Access Compliance Report

Public Rights-of-Way

(Curb Ramps)

Intersection ID: 3237	Main Street: HERITAGE_HILLS_LN	Cross Street: MACKINAC_ST	Location: NE
ADA ID: 720B3AFA9BD5	Ramp Type: Directional1	Initial Pass/Fail: Fail	Overall Compliance: No
Severity Score: 12.5			
Codes/Mitigation Info/Possible Solution		Field Measurements/Component Compliance

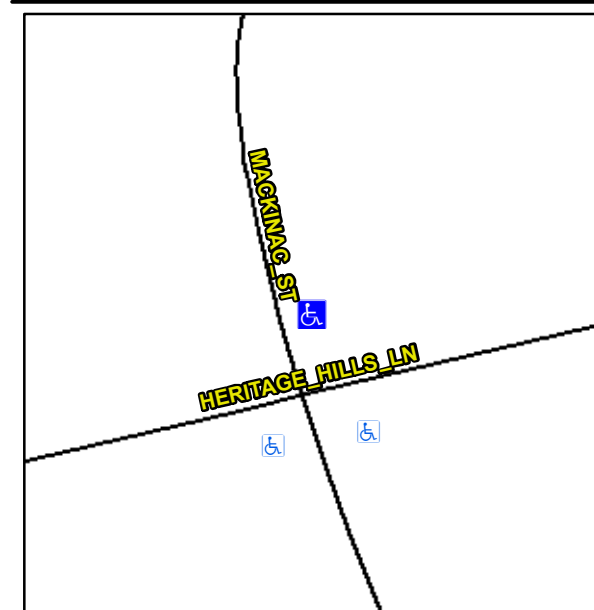
Compliance	Description	Data	Compliance	Description	Data
N/A	Ramp Length (in)	57.0	N/A	Grade Break?	N/A
Yes	Ramp Width (in)	48.0	N/A	Grade Break Slope (%)	0.0
Yes	Ramp Slope (%)	6.6	N/A	Grade Break XSlope (%)	0.0
No	Ramp XSlope (%)	6.0			
N/A	Flare Type LT	N/A	N/A	Flare Type RT	N/A
N/A	Flare Slope LT (%)	N/A	N/A	Flare Slope RT (%)	0.0
N/A	Flare Traversable LT?	N/A	N/A	Flare Traversable RT?	N/A
N/A	Landing Length (in)	0.0	N/A	DWS Provided?	N/A
N/A	Landing Width (in)	0.0	N/A	DWS Contrast?	N/A
N/A	Landing Slope (%)	0.0	N/A	DWS Length (in)	N/A
N/A	Landing X Slope (%)	0.0	N/A	DWS Full Width?	N/A
N/A	Landing Curb? (Y/N)	N/A	N/A	DWS Offset LT (in)	N/A
N/A	Shared Landing?	N/A	N/A	DWS Offset RT (in)	N/A
N/A	Gutter Ponding?	0.0	N/A	Gutter Slope (%)	N/A
N/A	Gutter Lip Ht (in)	0.0	N/A	Gutter X Slope (%)	N/A
N/A	Painted X Walk1?	No		Road Slope (%)	4.8
	X Walk 1 Direction	To S		Road X Slope (%)	3.6
	X Walk 1 Width (in)	N/A		Clear Space?	N/A

X Walk 1 Slope (%)	4.8	N/A	Clear Space to XWalk (in)	N/A
	X Walk 1 X Slope (%)	3.6	N/A	Storm Grate/Utility Hazard?	N/A
N/A	Ramp inside XWalk1?	N/A		Storm Grate/Utility Type	
N/A	Any Obstructions?	N/A			
	Obstruction Type		Yes	Surface Condition? (G/P)	Good
			N/A	Curb Slope (%)	N/A

Remove & Replace Entire Ramp.

R304.5.3
